RE: Critical Area Report Addendum – Pinnacle at Liberty Bay
Poulsbo Subdivision #P-06-20-25-03
SWC Job #24-158

This report describes our response to your September 8, 2025 “*Request for Revisions*” regarding the proposed Pinnacle at Liberty Bay development. This revision specifically addresses the comments in the peer review letter dated August 29, 2025 from Farallon Consulting/Grette Associates as follows;

BUFFER MITIGATION PLAN

PP-06

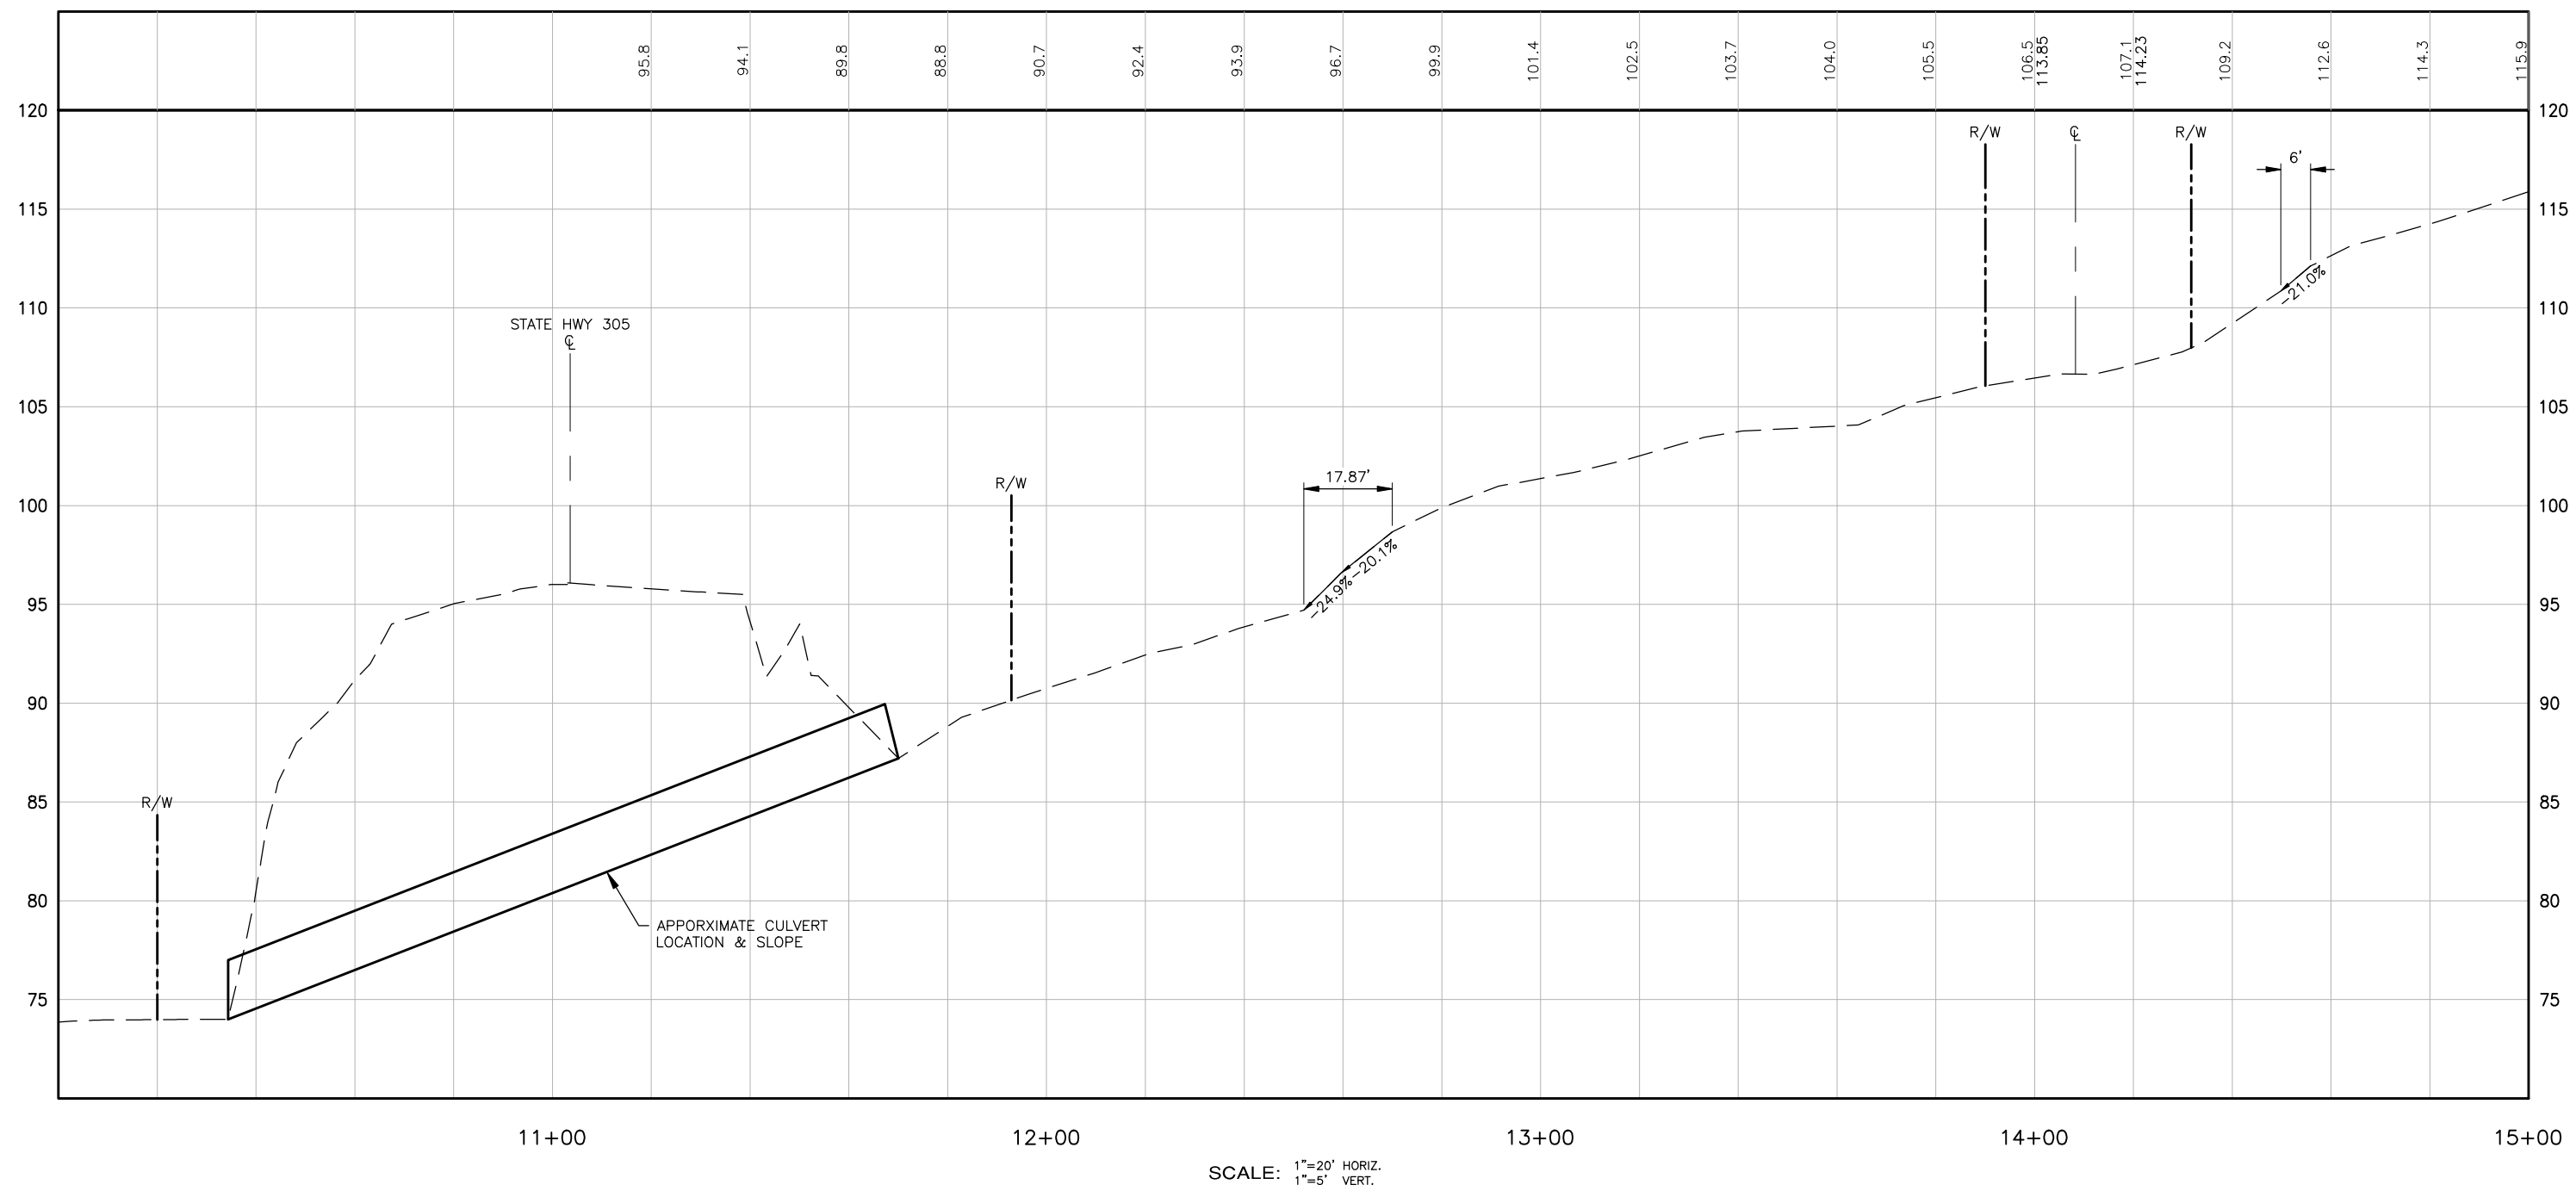
- Per PMC 16.20.230, Category III wetlands with a moderate habitat score (6-7 points)4 with a proposed high impact land use are subject to a 150-foot buffer. Based on the revised habitat score, the appropriate buffer width for Wetland C is 150 feet. The Plan should be revised accordingly.

- Per PMC 16.20.230, buffer averaging may be allowed if it will improve the protection of the wetland or if it is the only way to allow for reasonable use of the property. The Plan does not provide sufficient detail to support why a reduction to Wetland A's buffer is necessary and prevents reasonable use of the project site to support the proposed alignment of the road and residential park. The Plan should be revised to include additional information to demonstrate there is no feasible alternative to reposition the access road and that reducing the park area would not provide feasible recreational use. Please note that based on one of the figures provided in the plan (Attachment 1), it appears that the standard buffer is being applied to all of Wetland A, which appears to show averaging is not necessary.

- Per PMC 16.20.230, averaging may be allowed if it is the only way to allow for reasonable use of the property. According to the Plan, Wetland B's buffer needs to be reduced in three locations and states that it is necessary because of existing slopes and to better fit several lots. No further explanation to describe site constraints or rationale as to why there are no other design alternatives. The Plan needs to be revised accordingly.

- Per PMC 16.20.230, the increased buffer shall be in area that provides higher function compared to the proposed area to be reduced. The Plan describes that the reduced buffer area associated with Wetland B is primarily shrubs and that the increased area is primarily mature native vegetation but also states that the reduced area and the increased area provide similar function. Based on this summary, it is unclear that the increased buffer is in a high quality area compared to where the reduction is proposed. The Plan needs to be revised to further describe conditions for compliance with this requirement.

Response: The plan has been revised to show the 150' buffer off Wetland C as requested. The revised plan is attached.

Response: The proposed averaging of the buffer of Wetland A is shown on the north and west edge of the buffer. In this area the buffer is being reduced a total of 1,859sf with a minimum width of 37.5' which is 75% of the standard buffer as allowed by Code. The existing topography forces the city-required road connection (Road C) towards Wetland A. There is simply too much grade to make up between Road C and the Road A upslope. It's proposed location is intended to minimize grading adjacent to the wetland buffer. The road on the north requires a slope which will have this minor intrusion into the buffer. The road cannot be moved further north as it impacts the curve of the road which will impede traffic flow with a sharp curve. The area on the west is to make the small park area flat without a slope into the buffer. A total of 2,207sf of buffer will be added which is a net increase of 348sf of buffer area.

Response: The proposed averaging of the buffer of Wetland B is necessary to make efficient use of the site given the topographic constraints and grading necessitated by the City's maximum road grade of 12%. If we were permitted to create steeper roads, we could follow existing grades better and reduce the grading. But at 12%, we're chasing grades in a lot of places even with sizable walls (up to 20' in some locations). The reduced areas of buffer on the north are due to the fact that in order to utilize that narrow portion of the site and keep an access road to the lots, a minor amount of averaging will be required. The other two areas will require some grading in these areas due to the slope so averaging these will be required to allow lots on this area of the site.

Response: In general, the reduced buffer areas are similar in vegetative character as the added areas. These buffer areas are generally above the slope and as such are generally just added areas of habitat along the buffer as the slope is a barrier to some functions. The proposed averaging reduces the buffer by 11,509sf in 4 areas and adds 11,857sf of

buffer in 3 areas. This is a net increase of 348sf of buffer/habitat area that increases the habitat function of this area.

Fish & Wildlife Habitat Conservation Areas
DNR Hydrology Water Type Map

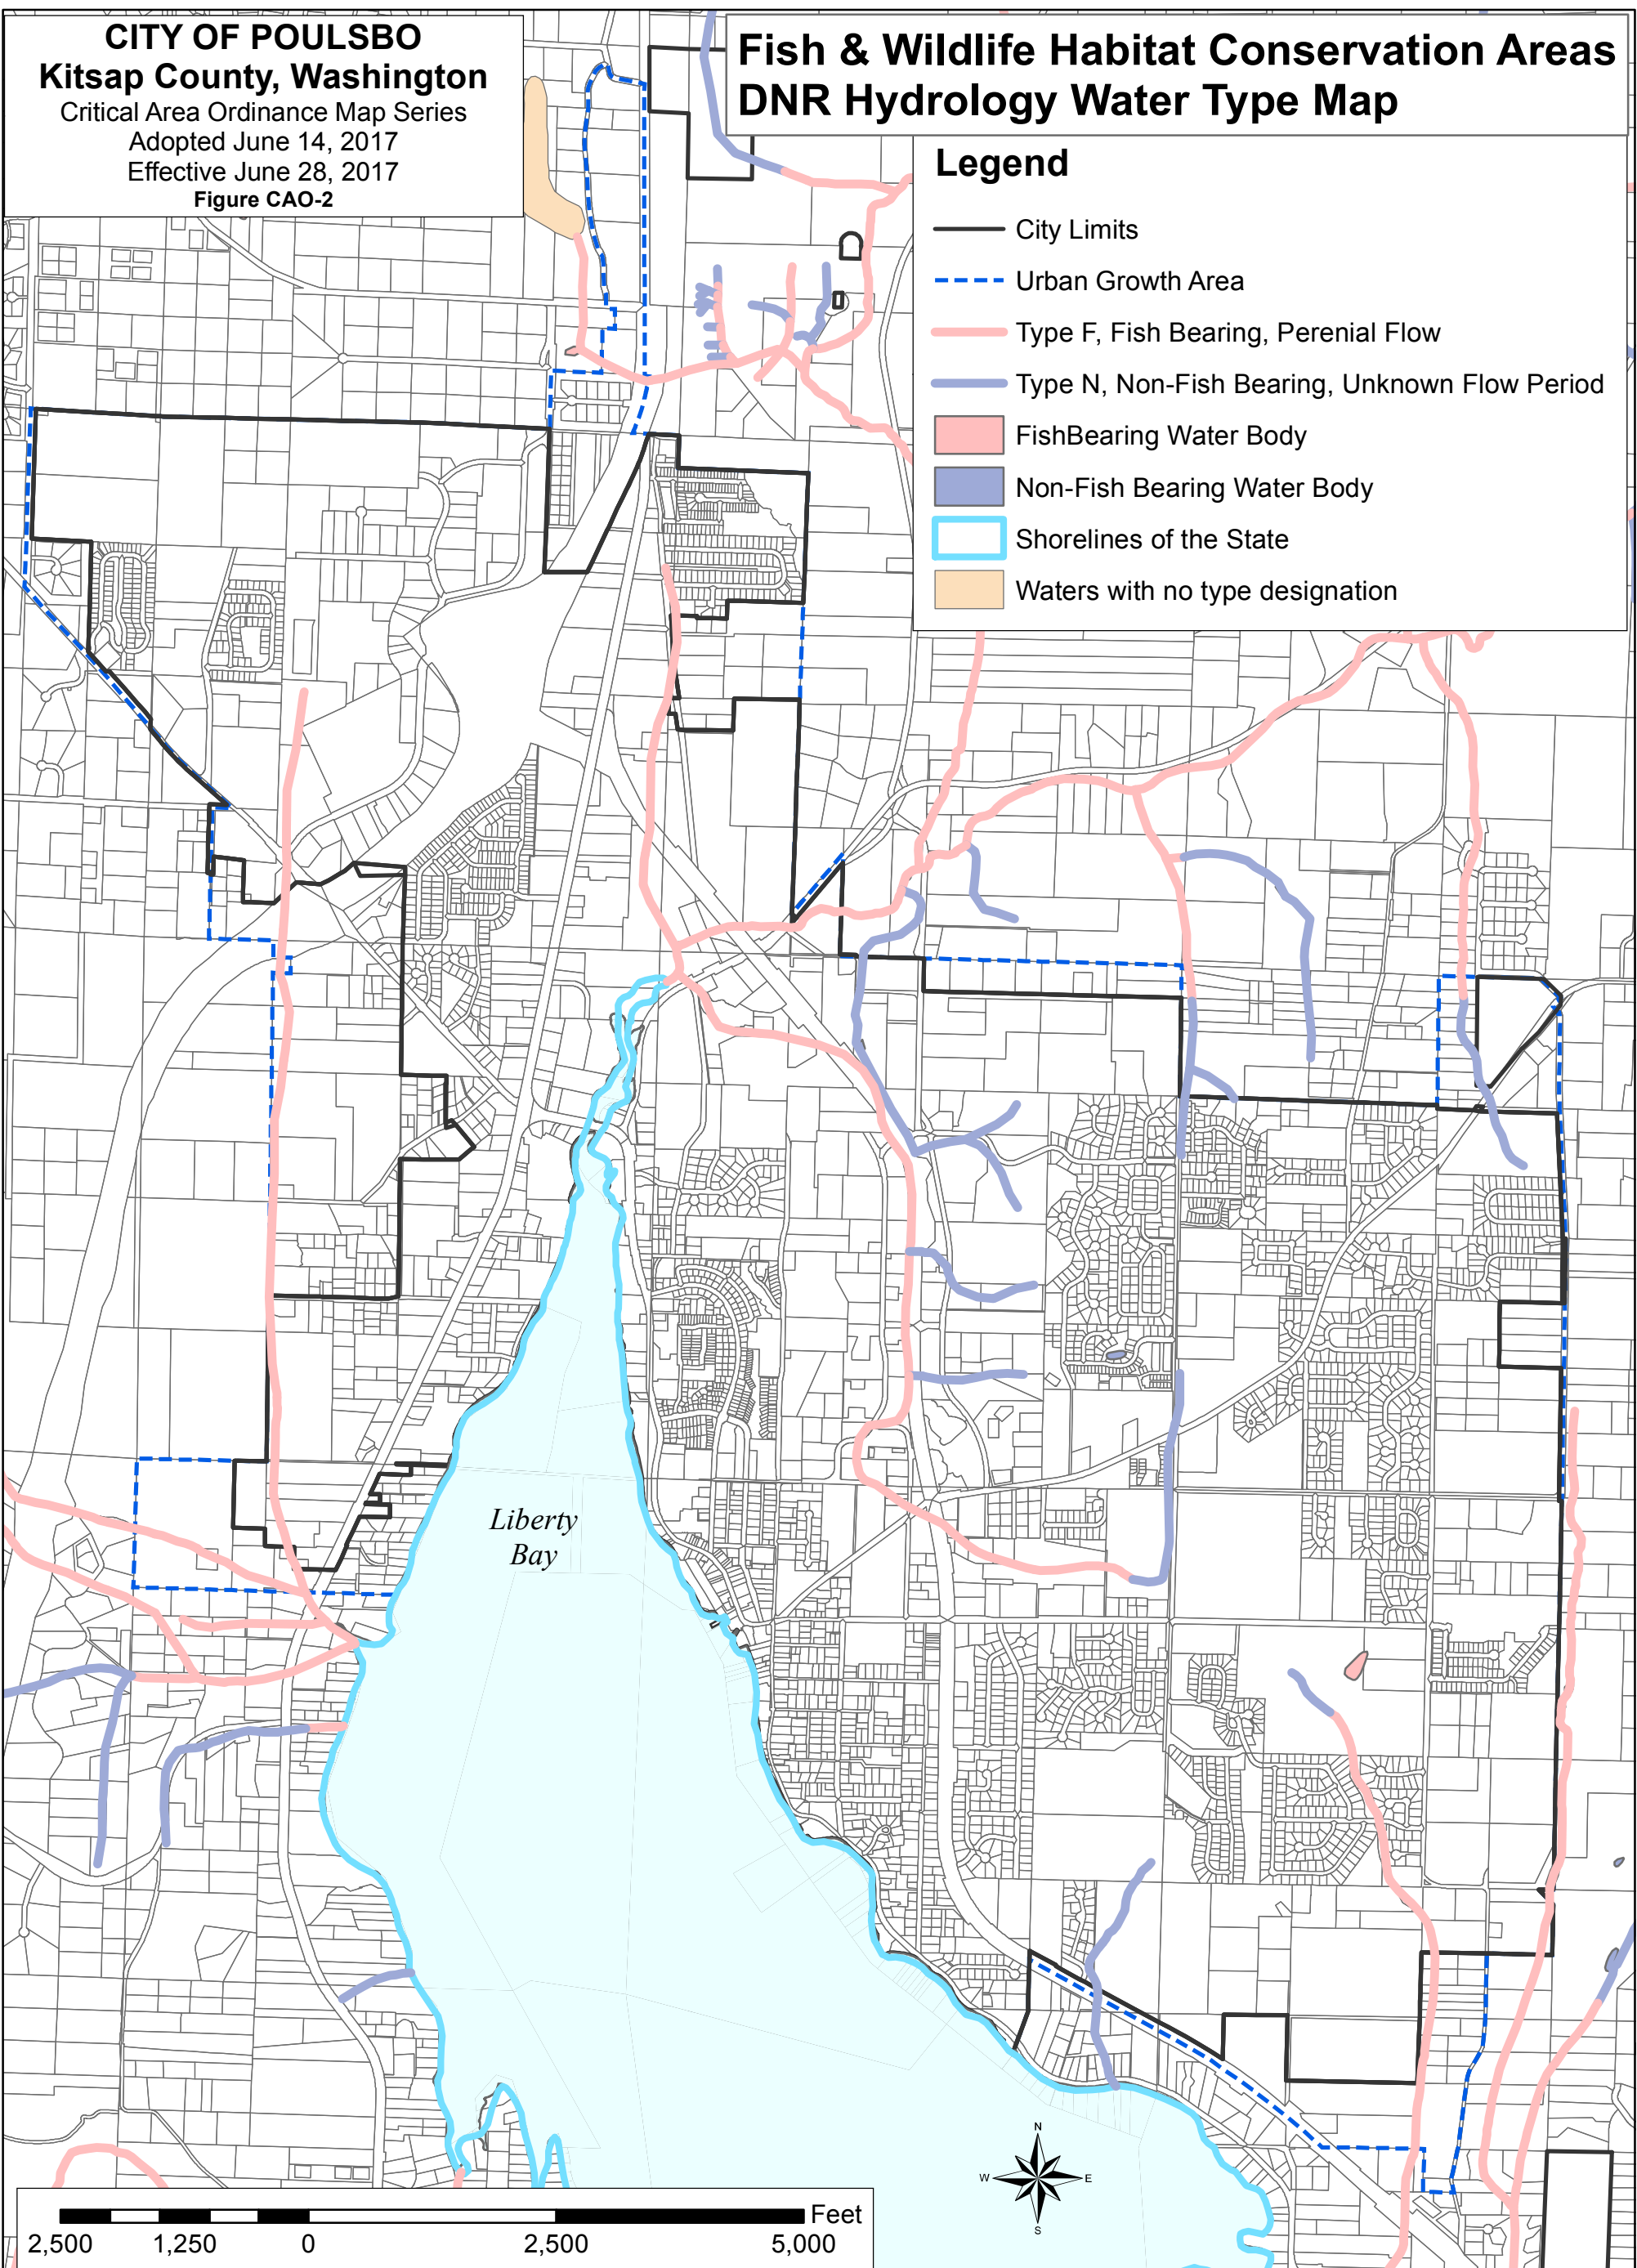
- Per PMC 16.20.315, Type F streams are subject to a 150-foot stream buffer and a 25-foot building setback. The Plan needs to be revised to reflect a 150-foot buffer for Stream C.

Response: SWC disagrees that Stream C should be classified as a Type F (fish-bearing) water. It is classed by Washington State Department of Natural Resources (DNR) mapping as a Type N stream, which mapping governs stream types under City of Poulsbo critical areas regulations, as discussed below.

We have attached the WADNR and WDFW maps that specify this is a Type N stream to this addendum.
